STAFF REPORT
COMMUNITY DEVELOPMENT DEPARTMENT

HEARING DATE: 6/7/2022
 TO: Mayor & City Council
 FROM: Joseph Dodson, Associate Planner
 208-884-5533
 SUBJECT: H-2021-0103
 Ferney Subdivision

Annexation and Zoning of 5.64 acres with a request for the I-L zoning district and a Preliminary Plat consisting of two (2) building lots on 4.93 acres of land in the requested I-L zoning district.

D. Conceptual Building Elevations (full file linked [here](#))

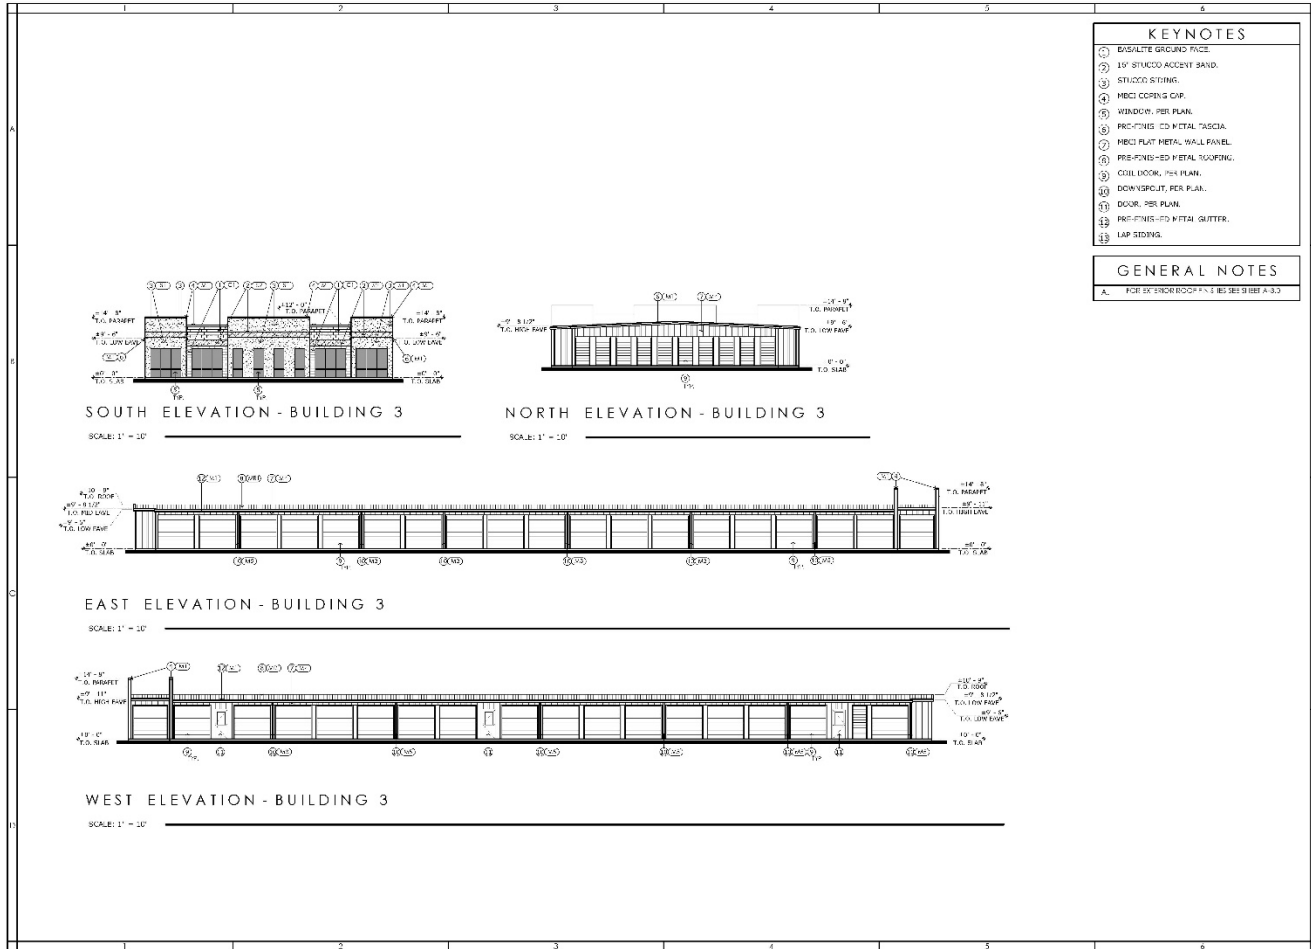
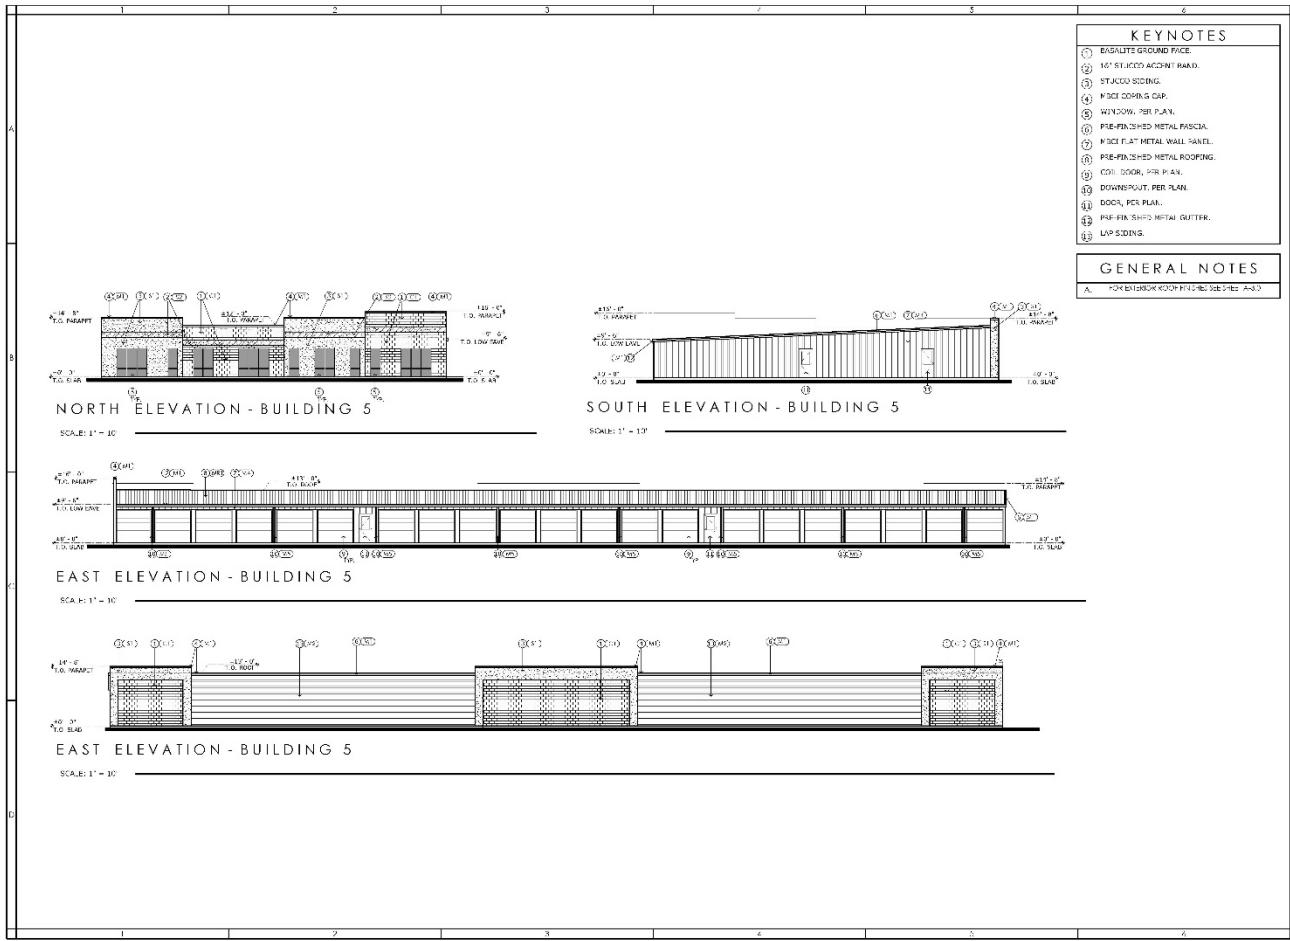
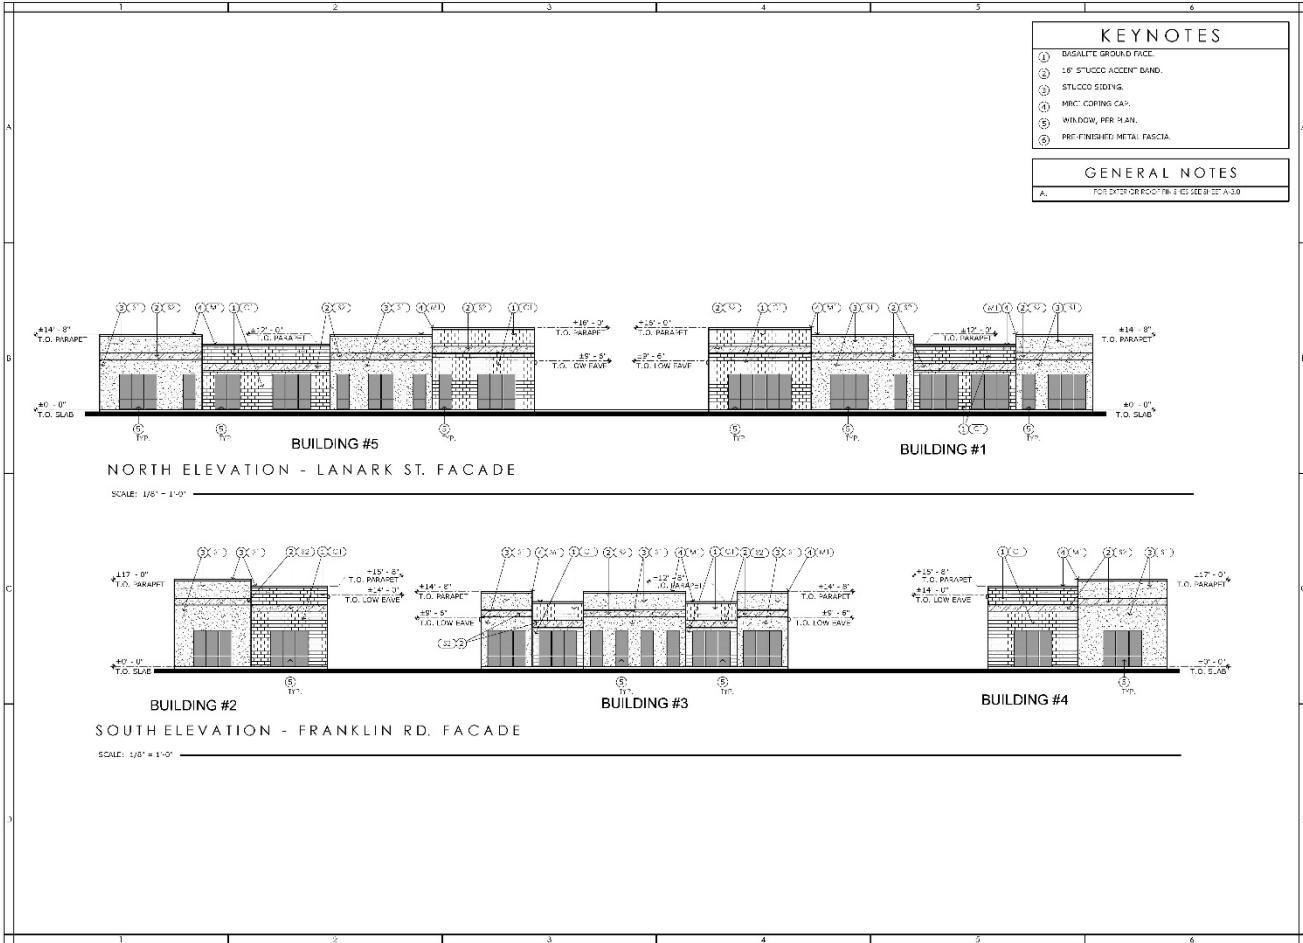
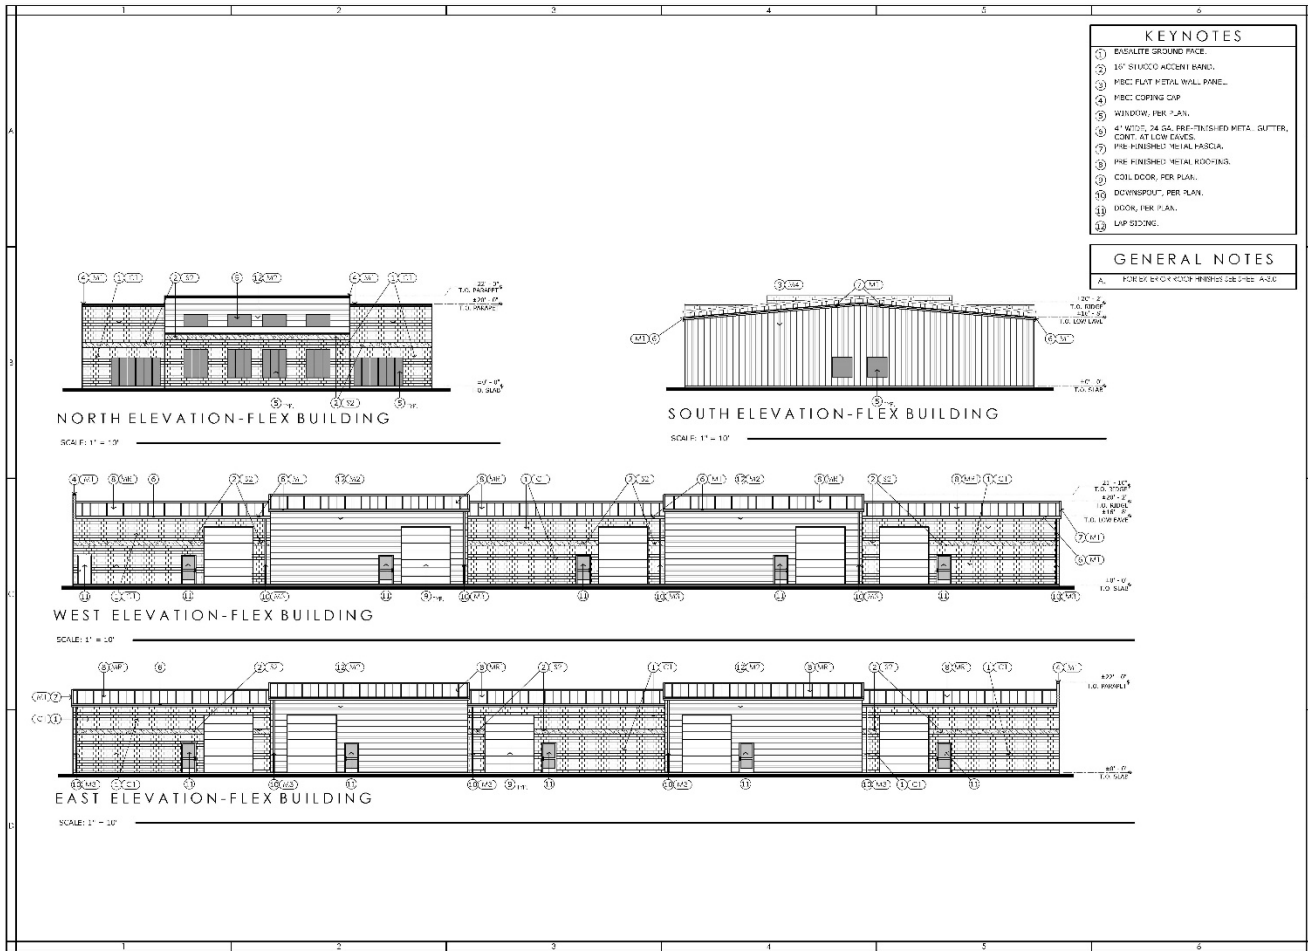
The conceptual elevations submitted depict 17-foot tall storage buildings at their highest and a 21-foot tall flex building. The storage buildings vary in overall size but appear to show varying roof profiles and finish materials facing relevant areas (roadways and the residence to the east). However, it is not entirely clear if the paneling shown facing the residence is metal or otherwise; metal paneling will not be allowed as a future field material. Overall, Staff finds the conceptual elevations should comply with the relevant standards but will review it in more detail at the time of CZC and Design Review submittal.
